RE: Bid Title: Woodville Community Center Library Addition  
Bid No: BC-07-29-10-23  
Opening Date: Thursday, July 29, 2010 at 2:00 PM

### ADDENDUM #1

Project Name: Leon County Library  
Woodville Branch

Addendum #1

SITE PLAN

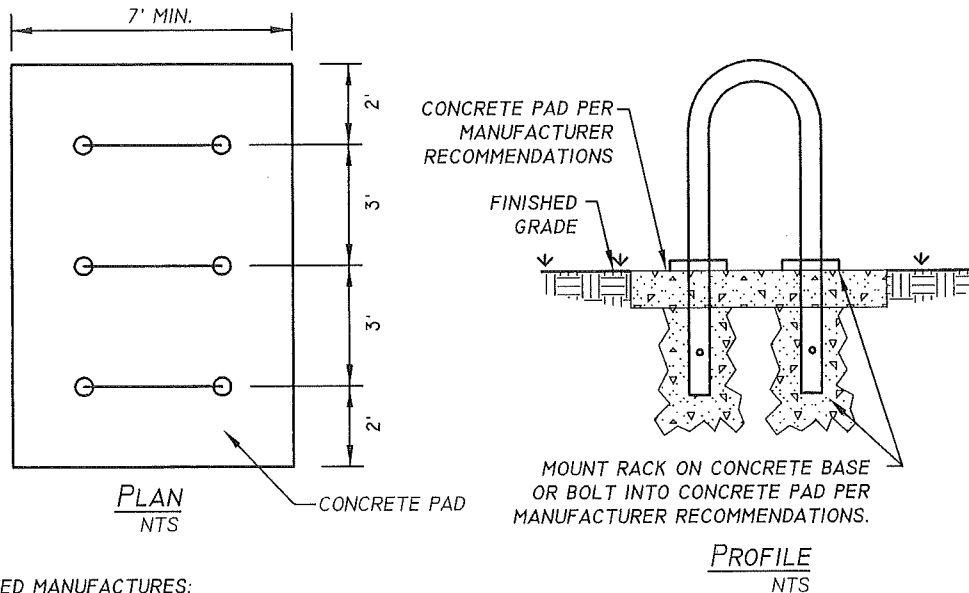
5. Is the bike rack remove and replace or remove and reuse? If replace, please clarify with a specification.

***Bike rack shall be removed and replaced as shown on sheet C5.***

**D1.1**

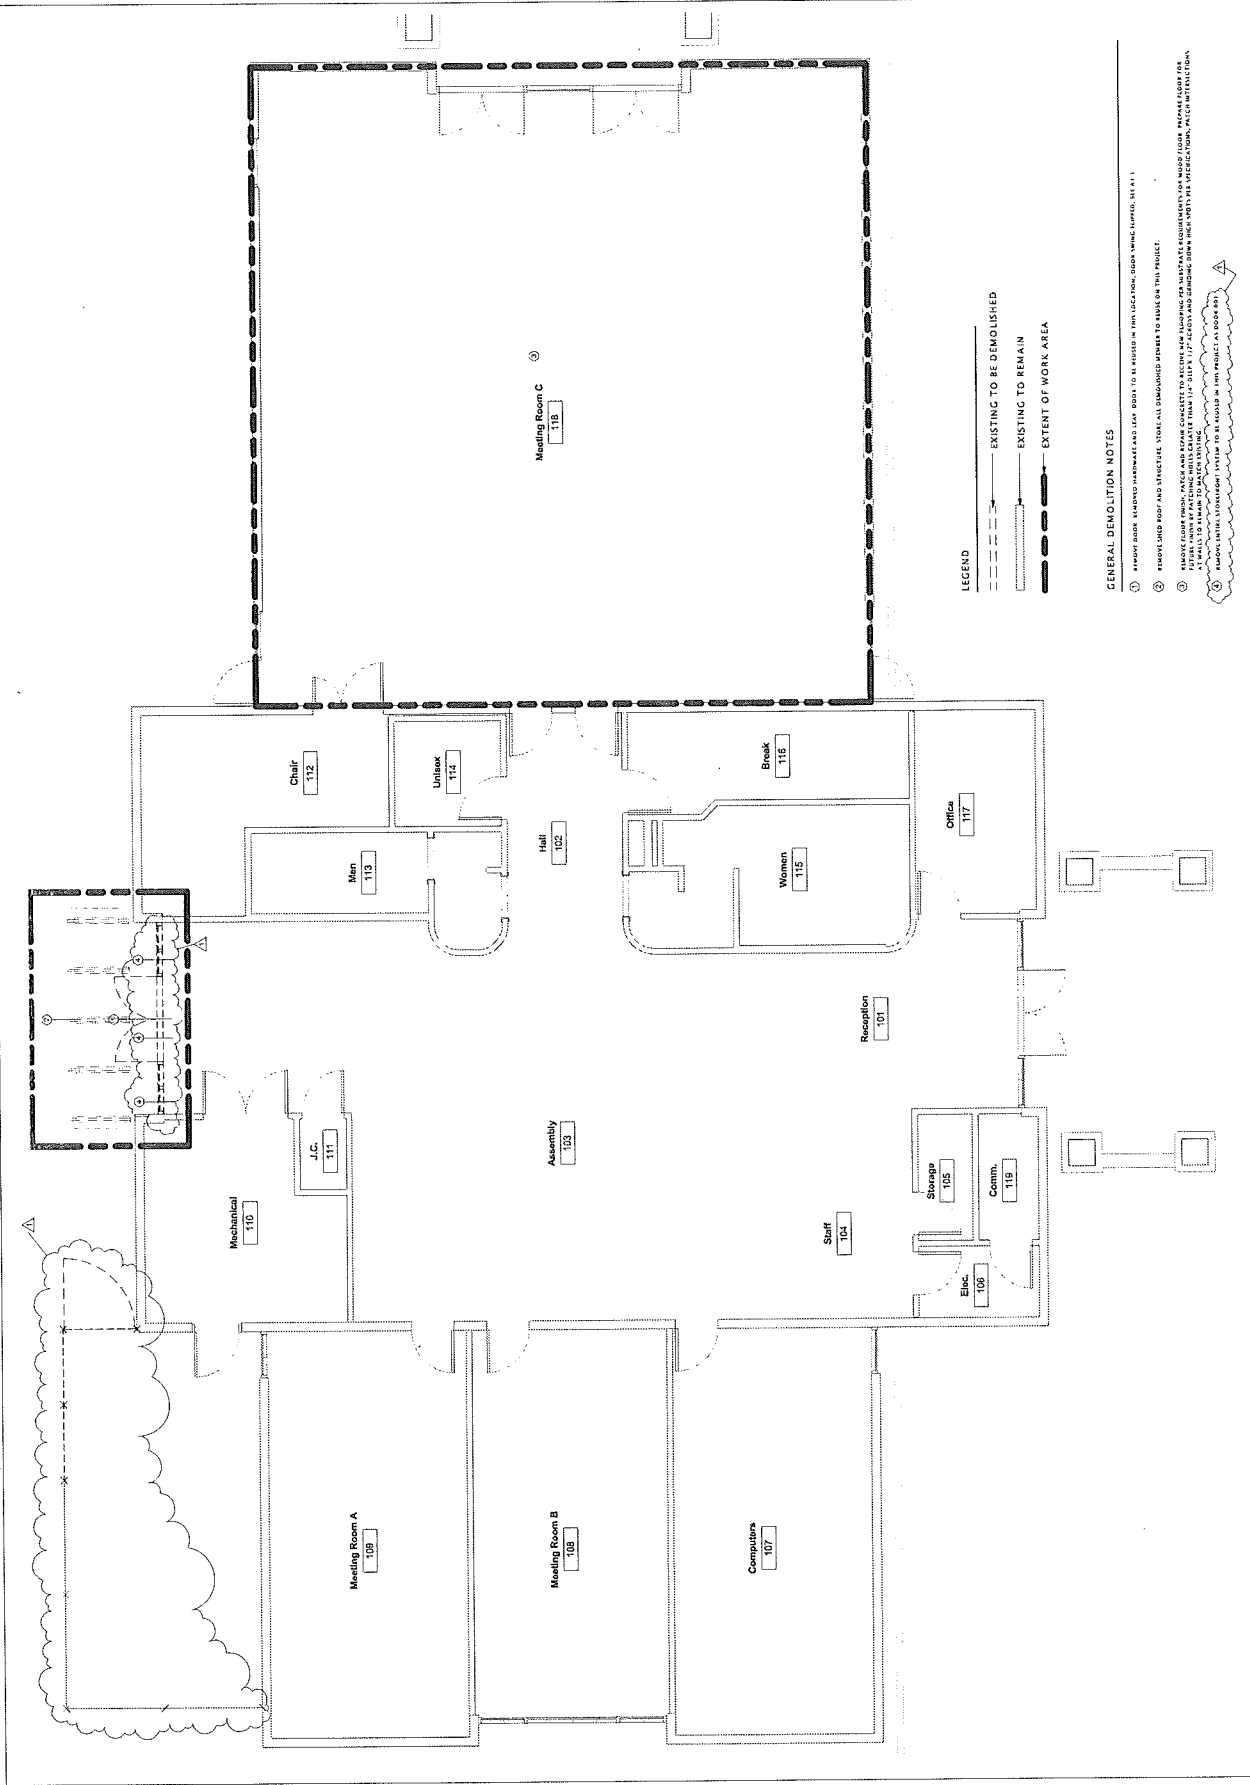
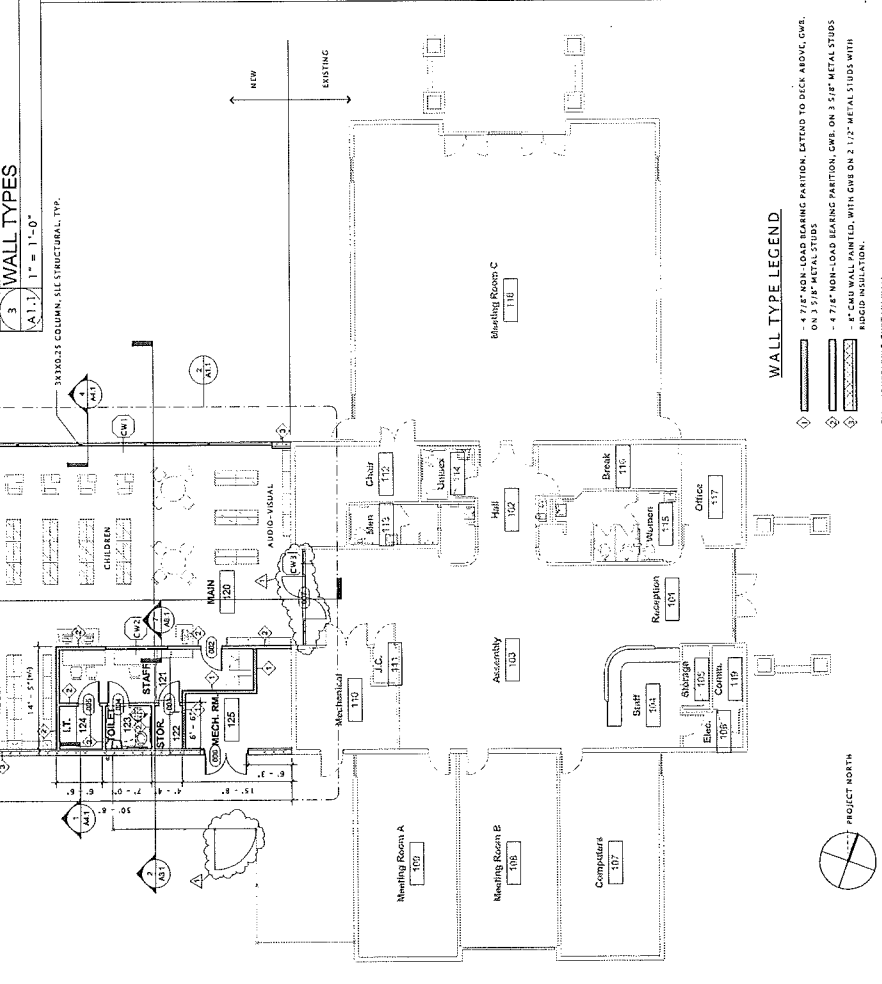
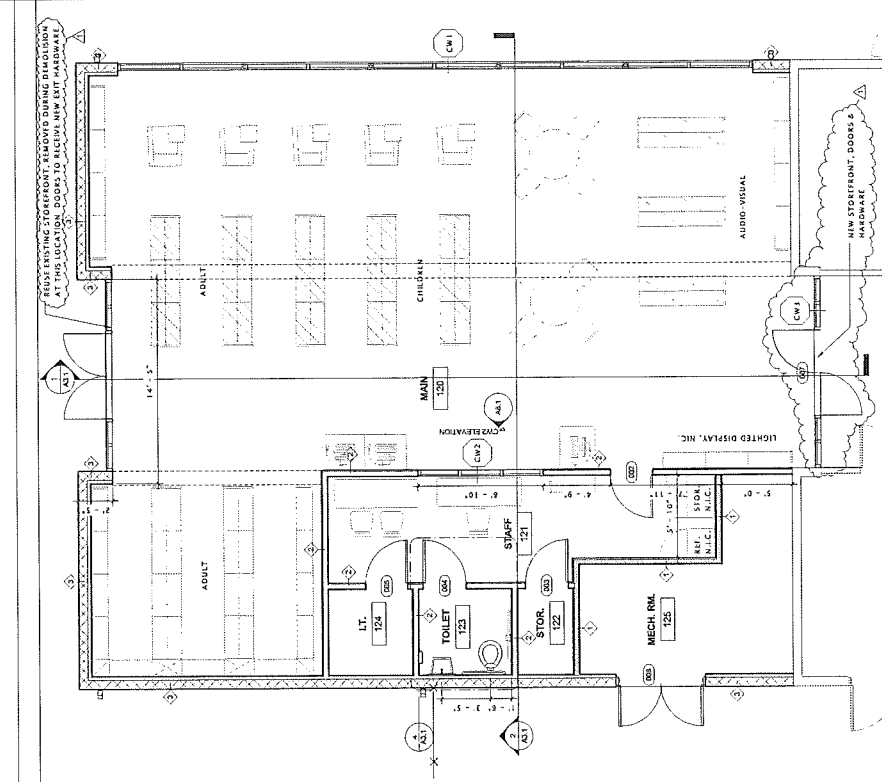
3. A1.2 identifies a "new fence to match existing". What is the existing fence? Please provide a specification or clarification of what is acceptable.

4. Fence – is there a gate as identified on A1.2? A1.1, A1.3, A2.1, LS1 do not indicate a gate. If the gate is relevant to the project, what are the gate dimensions? Is lockable hardware (lock provided by others) required? Please provide a spec or clarification of what is acceptable.

***See updated D1.1 showing existing fence and gate.***

***Existing gate will be removed and lockable hardware will be removed, and reused in new fence. See updated D1.1 showing existing fence and gate.***

**1 REFLECTED CEILING PLAN**  
A1.2 1/8" = 1'-0"

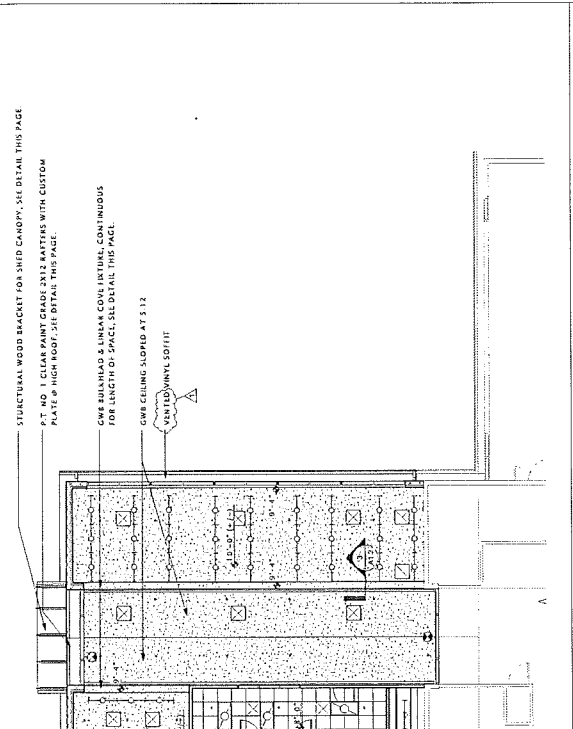
20. Which soffit is correct? A1.2 unvented vinyl, A4.1 & A8.1 Vented vinyl soffit, or S-3 Vented Hardisoffit panel. Is there Vented Vinyl soffit on this project? If so, please provide a spec or

29. What happens to the underside of the canopy on A1.2? Is it painted? Is the vented vinyl soffit applied? Is it left alone? Painting the rafters is the only item called out. Please provide a spec or clarification of what is expected.

***Yes, vented soffit is used on this project. Provide vented soffit to match existing, the existing is Metal Sales 26 gauge, 12" coverage with striation; color is Linen White #81.***

**The underside of canopy is painted. The existing canopy should be reused in this location as much as possible. Repaint as necessary.**

**2 CANOPY DETAIL**  
A1.2 1/2" = 1'-0"

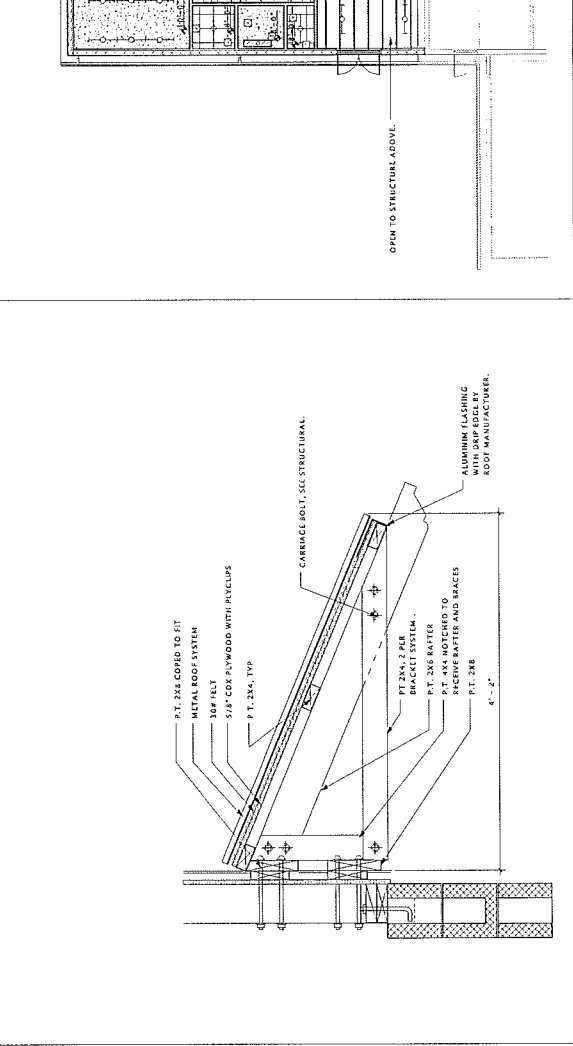
22. Canopy detail 2/A1.2 identifies 2"x8" pt and 2"x6" pt, canopy detail B/S-3 identifies HSS 4"x6"x1/4". Which is correct?

23. Which rafter is correct; A1.2 2"x6" in the canopy detail or 2"x12" as identified on the reflected ceiling plan?

***2/A1.2 is correct. As noted on D1.1 the existing canopy should be reused as much as possible, at this location. The 2"x8" pt and 2"x6" pt are reflective of the existing canopy. Should metal roof of canopy be damaged during removal, provide new metal to match existing.***

***2"x6" is correct. As noted on D1.1 the existing canopy should be reused as much as possible, at this location. The 2"x6" pt is reflective of the existing canopy.***

1 FINISH FLOOR PLAN  
A1.3/ 1/8" = 1'-0"

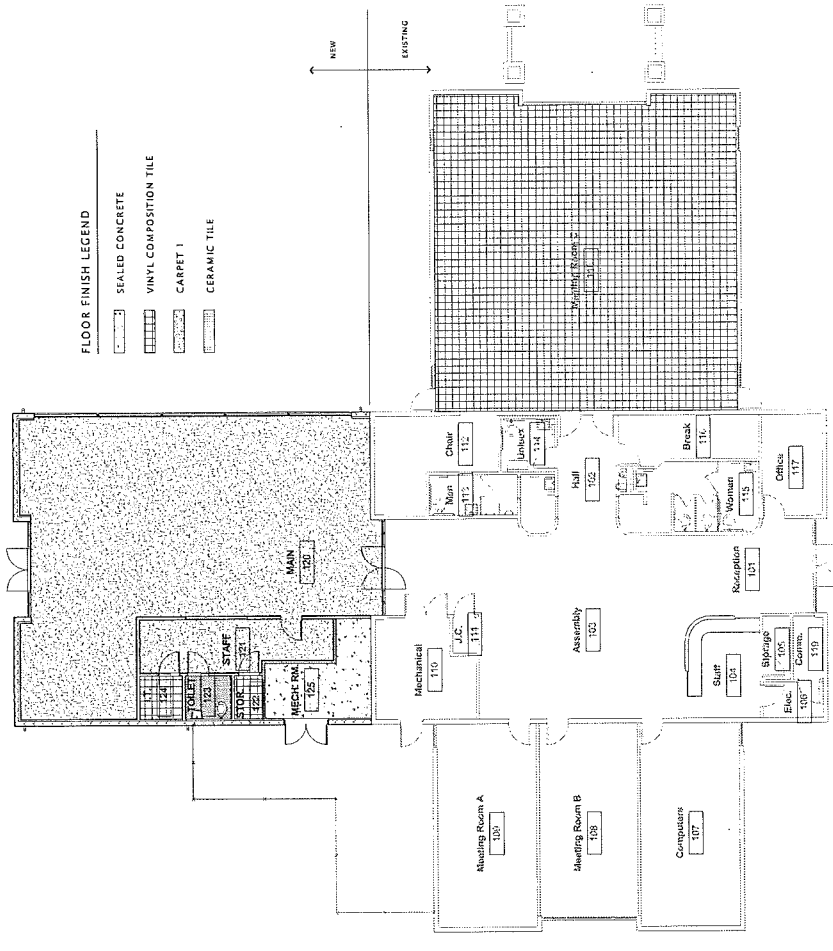
28. A1.3 shows on the drawing Room 118 getting VCT that is also shown on the demo plan though the schedule shows Room 119 getting VCT and Room 118 remaining the same. Could you please clarify?

**Room 118- Meeting Room C is to receive new VCT. Room 119- Comm is to remain the same. See revised A1.3 delineating change and 6" rubber base in Room 118.**

WINDOW &  
DOOR  
SCHEDULES &  
DETAILS

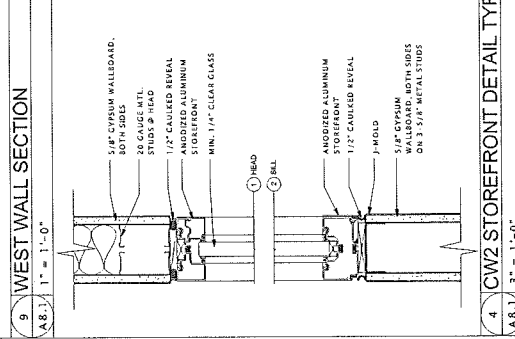
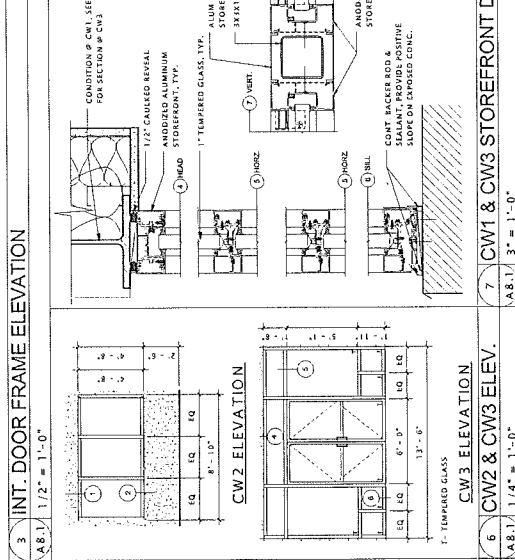
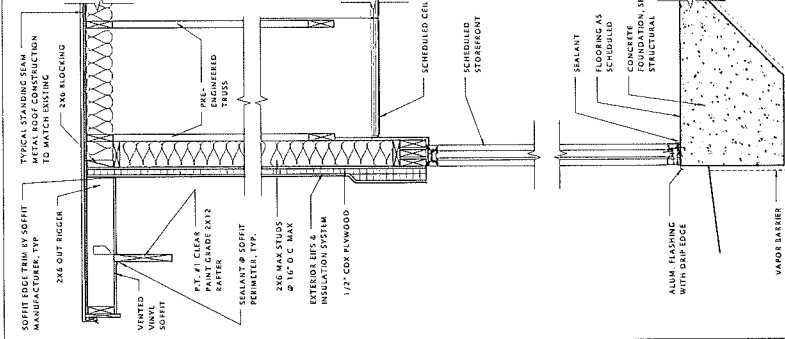
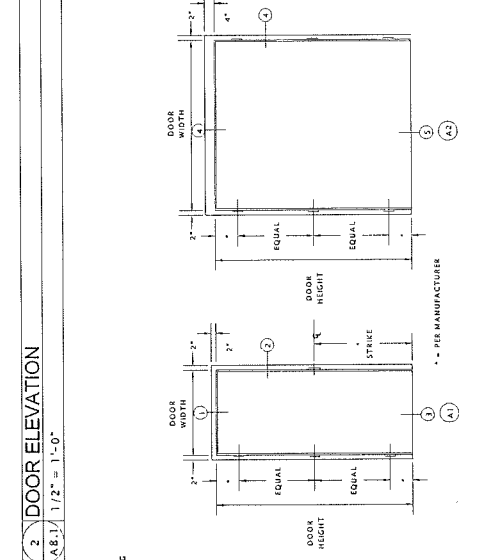
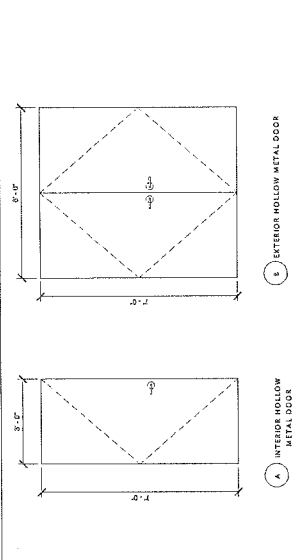
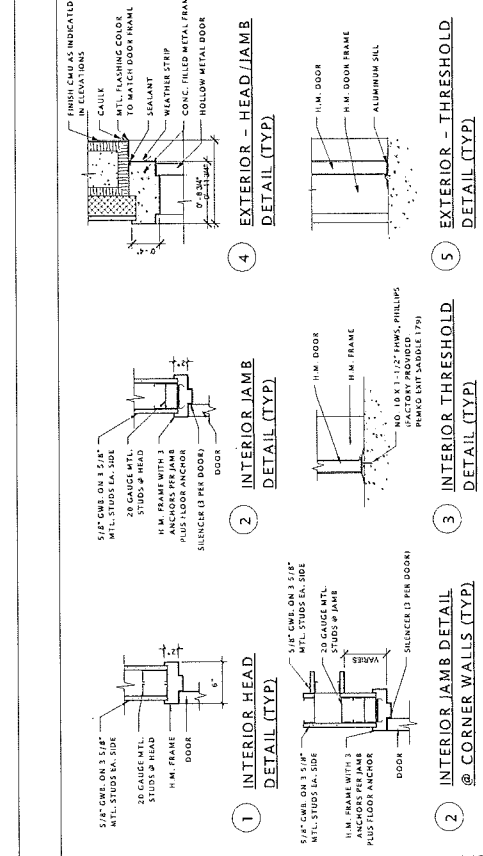
25. Door Schedule on A8.1 shows hardware set to be #6. There is no #6 in specs.

26. Door Frame A2 is not listed on the Door Schedule, C1 is. Does C1=A2?

27. A8.1 also shows doors as existing and on plan view A1.1 shows change door leafs only.

***Hardware set #6 omitted, Door 001 & 007 shall have hardware set #5. Contractor to provide power to door and fire alarm input. See revised attached sheets A1.1, A8.1 & SKE-1, 3-5.***

***Yes, this is a typo, C1=A2.***

***The entire existing storefront and doors shall be removed and reused in project as Door 001 with new hardware set #5. New storefront CW3 and doors to be installed at location for Door 007 with hardware set #5.***
